NOTICE OF DENIAL

RE: Application Number 22-8057; 691 W. Canfield; West Canfield Historic District

CERTIFICATE OF APPROPRIATENESS

691 W Canfield SCOPE OF WORK

PARTIAL BASEMENT PLAN VIEW REAR ELEVATION

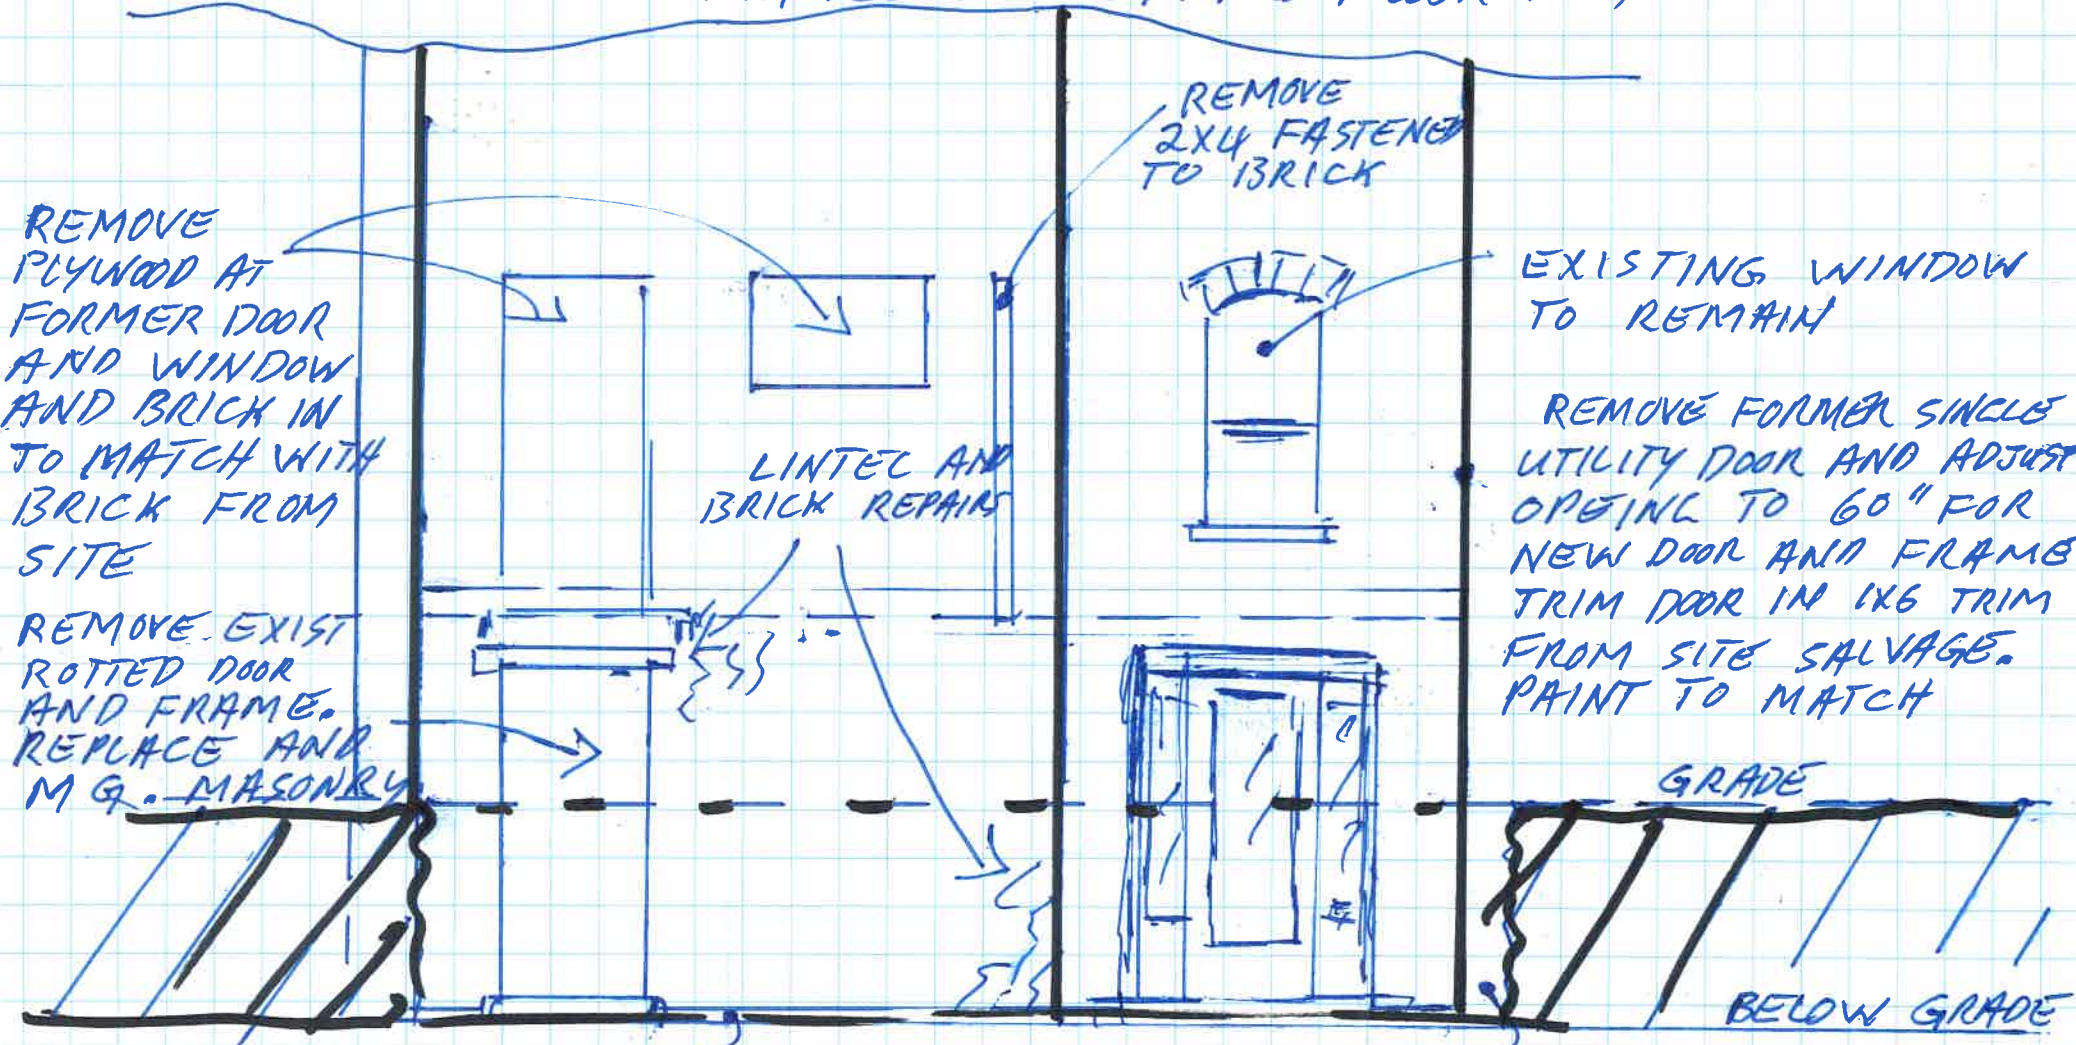
NO CHANGES SECOND/THIRD FLOOR REAR ELEVATIONS

GENERAL NOTE:
MAKE GOOD EXISTING
BROKEN / LOOSE / MISSING
BRICKS WITH BRICKS TO
MATCH

691 W CANFIELD ST DOOR AND WINDOW REPLACEMENT SCHEDULE

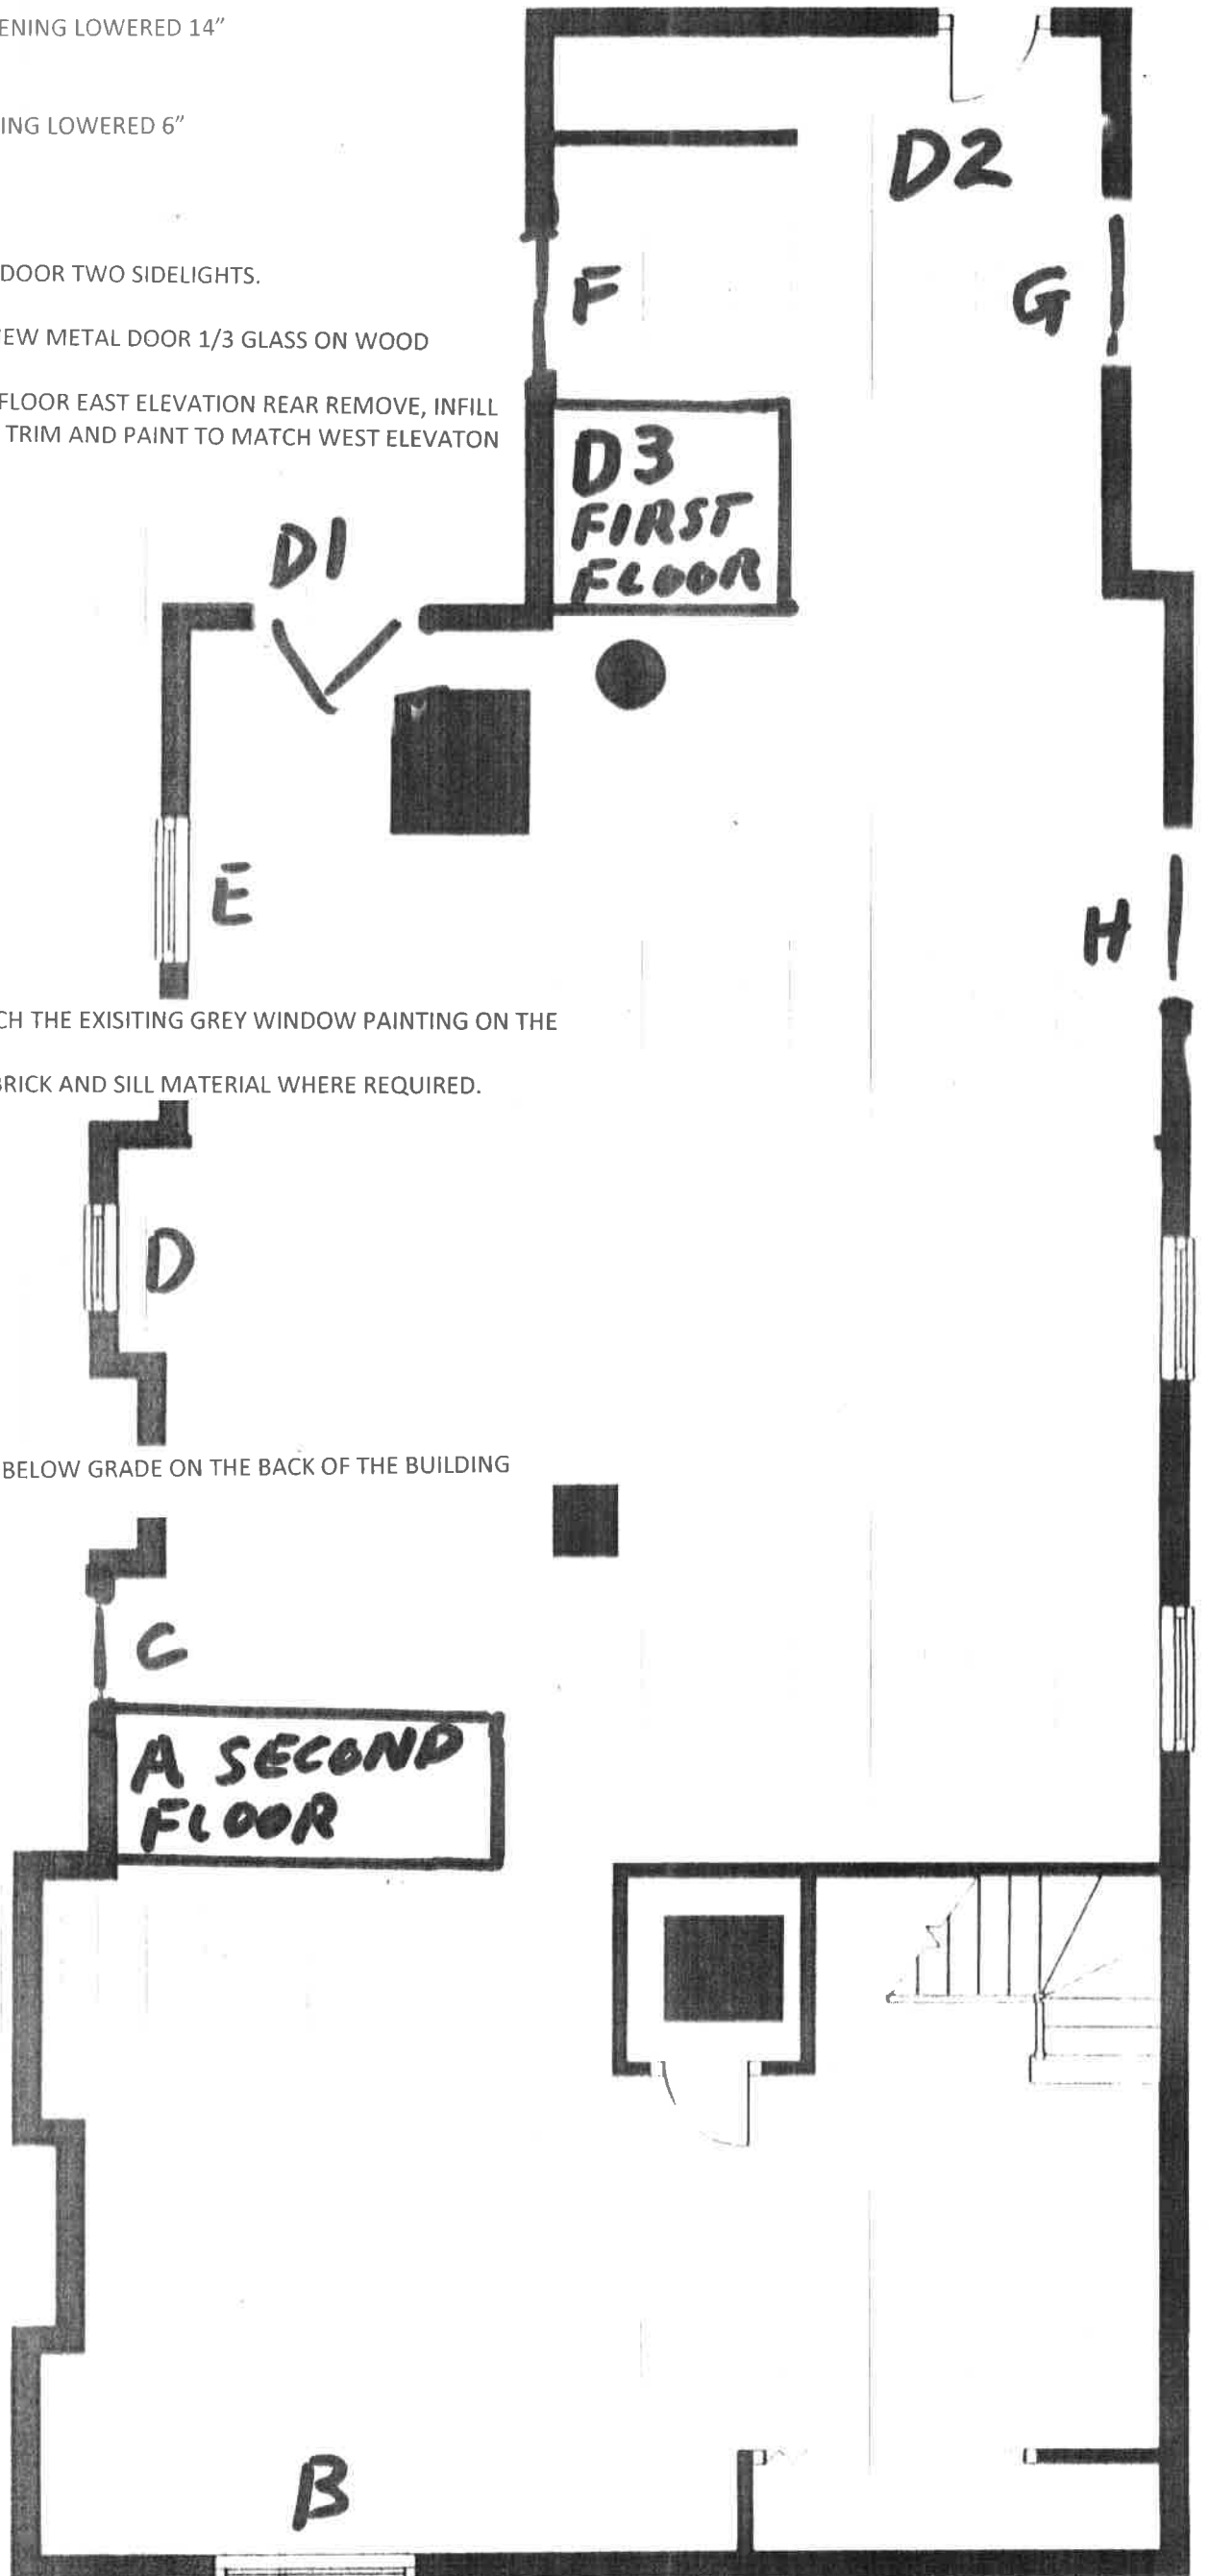
SECOND FLOOR - ONE WINDOW ADDED TO EXISTING OPENING. OPENING EXTENDED IN LENGTH
 "A" EAST ELEVATION, VINYL, SINGLE HUNG, REPLACEMENT, PAINT TO MATCH

BASEMENT - ONE NEW WINDOW ADDED, 6 REPLACEMENT WINDOWS TOTAL 7
 "B" NORTH ELEVATION, VINYL, SINGLE HUNG, REPLACEMENT OPENING LOWERED 10"
 "C" EAST ELEVATION, VINYL, SINGLE HUNG, NEW OPENING
 "D" EAST ELEVATION, VINYL, SINGLE HUNG, REPLACEMENT OPENING LOWERED 14"
 "E/F" EAST ELEVATION, VINYL, AWNING, REPLACEMENT
 "G" WEST ELEVATION, VINYL, AWNING, REPLACEMENT
 "H" WEST ELEVATION, VINYL, CASEMENT, REPLACEMENT, OPENING LOWERED 6"

"D1" EXISTING UTILITY REMOVED AND REPLACED WITH GLAZED DOOR TWO SIDELIGHTS.
 OPENING WIDENED TO SUIT. LINTEL INSERTED TO CARRY BRICK
 "D2" EXISTING UTILITY DOOR REMOVED AND REPLACED WITH NEW METAL DOOR 1/3 GLASS ON WOOD
 FRAME. REBUILD FAULTED SILL AND LINTEL
 "D3" EXISTING NON ORIGINAL ROTTED GLASS DOORS ON FIRST FLOOR EAST ELEVATION REAR REMOVE, INFILL
 WITH FISH SCALE CEDAR SHINGLES TYPICAL TO WEST ELEVATION, TRIM AND PAINT TO MATCH WEST ELEVATION
 SHINGLES. STAINGLASS TRANSOM WINDOW OVER TOP.

EAST SIDE

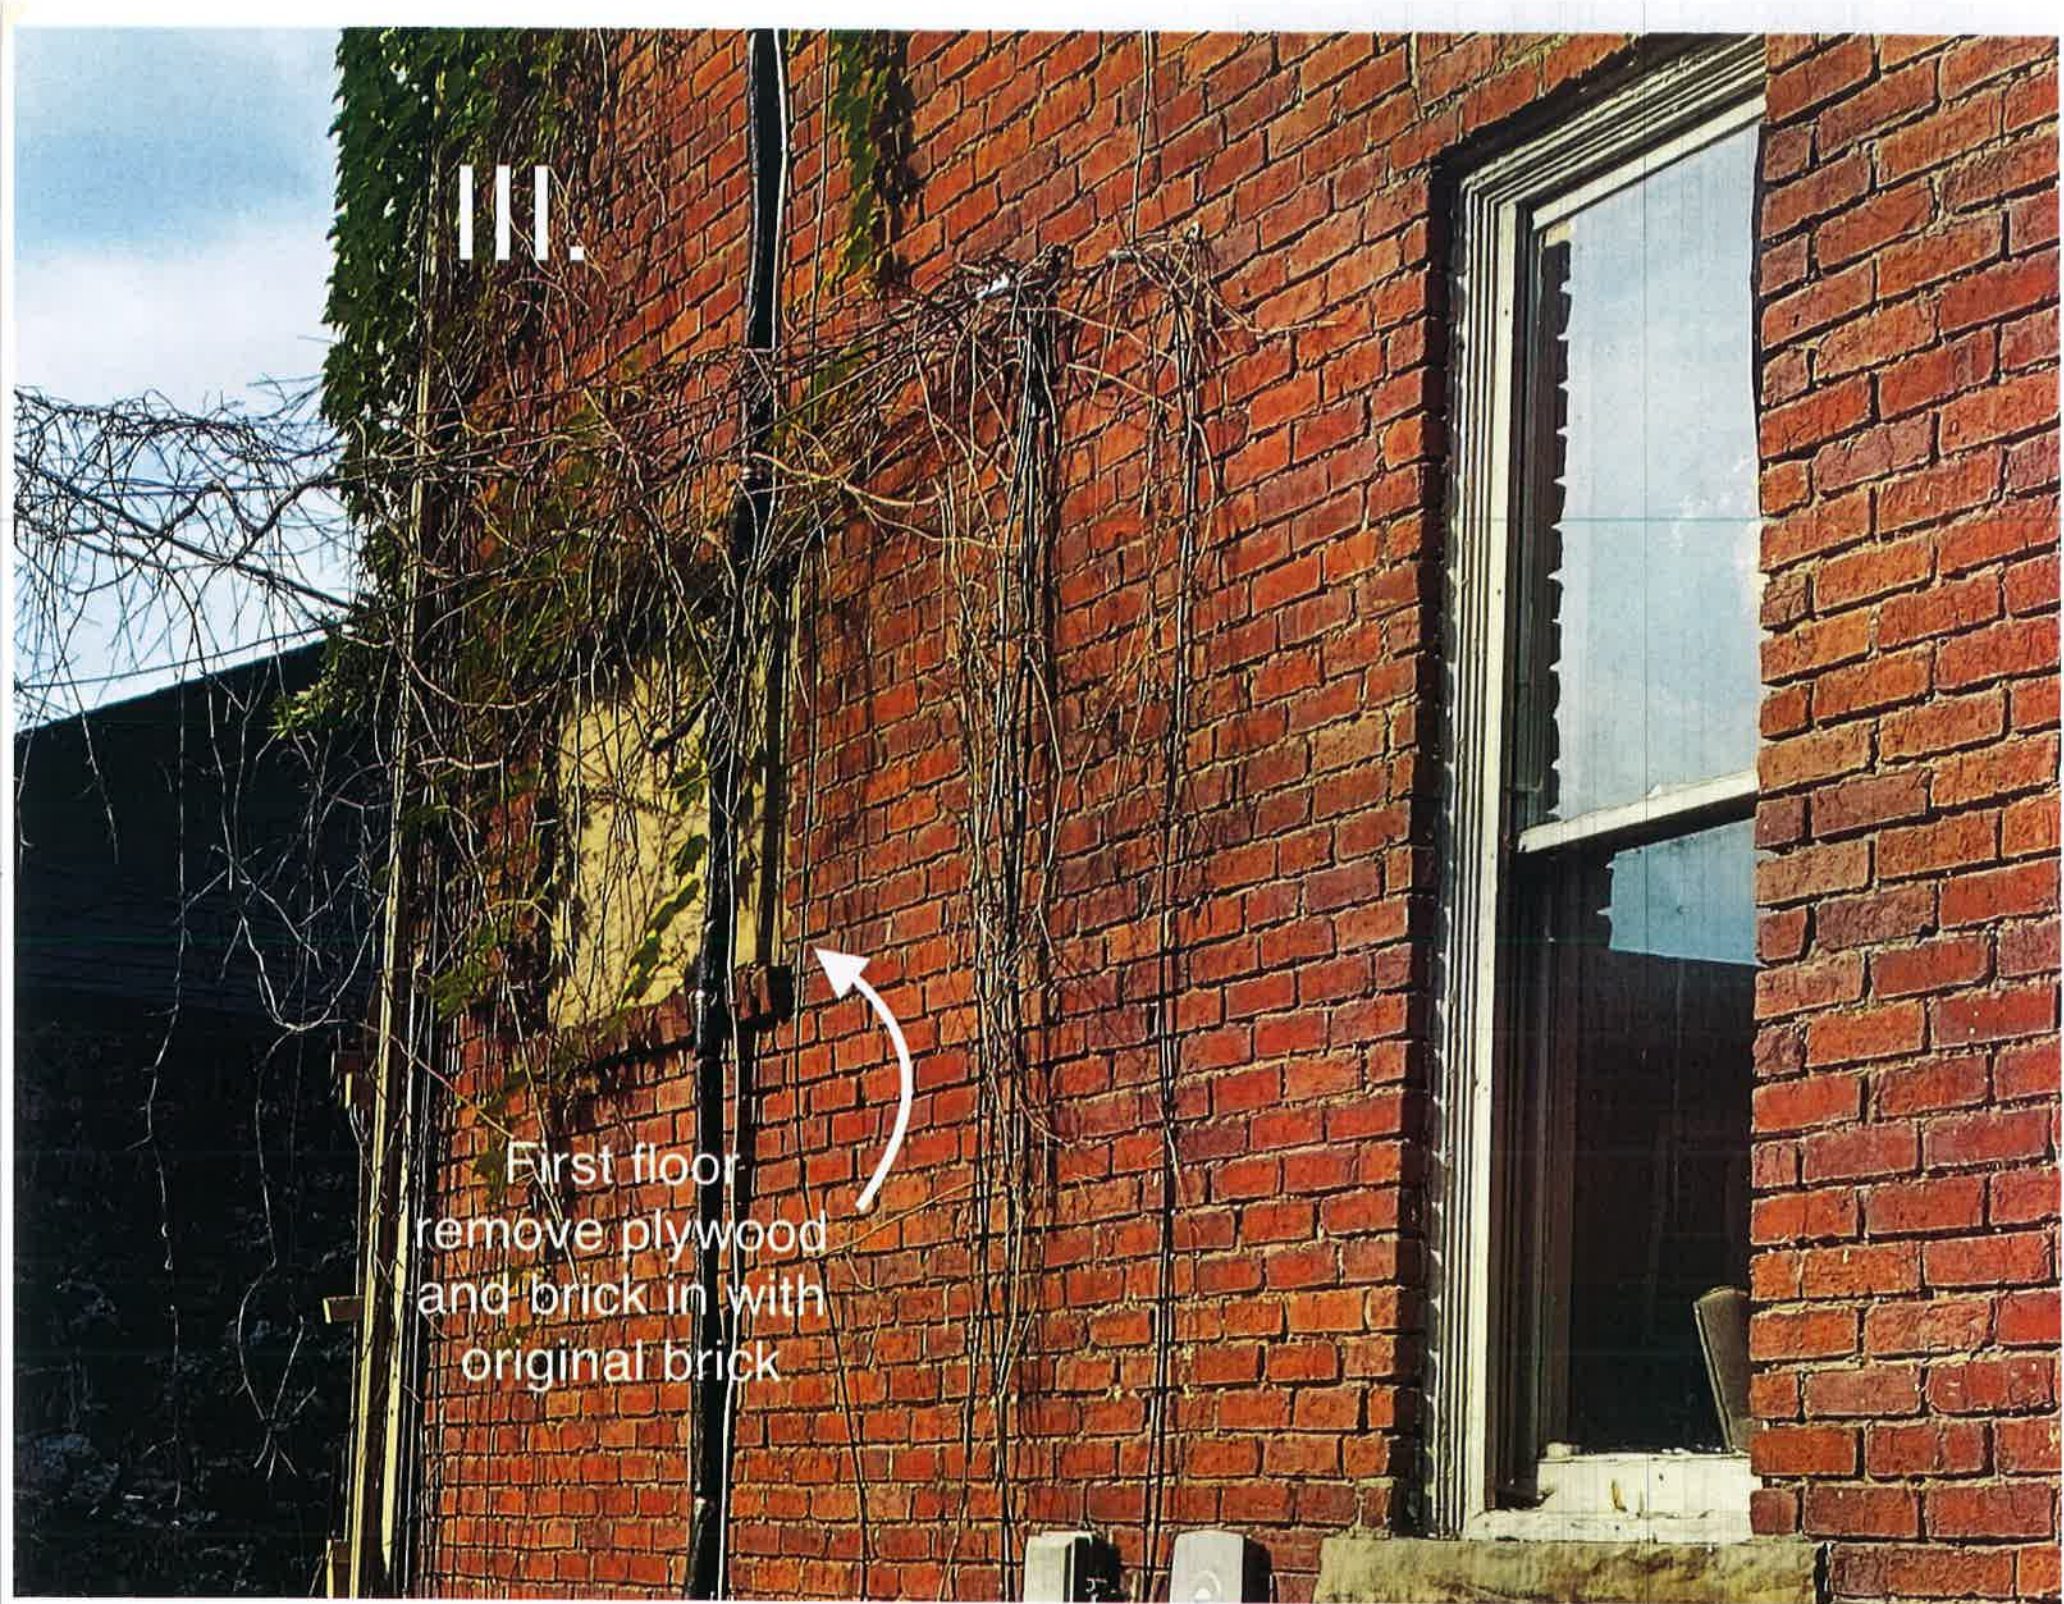
Add window here

Brick in here

2nd floor remove old plywood add single hung window on left to match below and brick in opening on the right
